M24128X-FCU read operations on chip enable register update

This errata sheet applies to M24128X-FCU, a 128-Kbit serial I²C bus EEPROM, with configurable device address and software write protection, delivered in 4-ball CSP.

1 Description of the change

Figure 1. Old figure

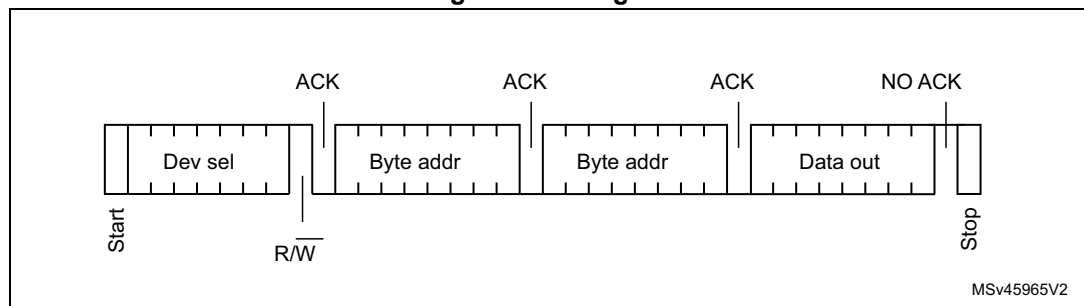
The figure must be modified as a standard random address read from:
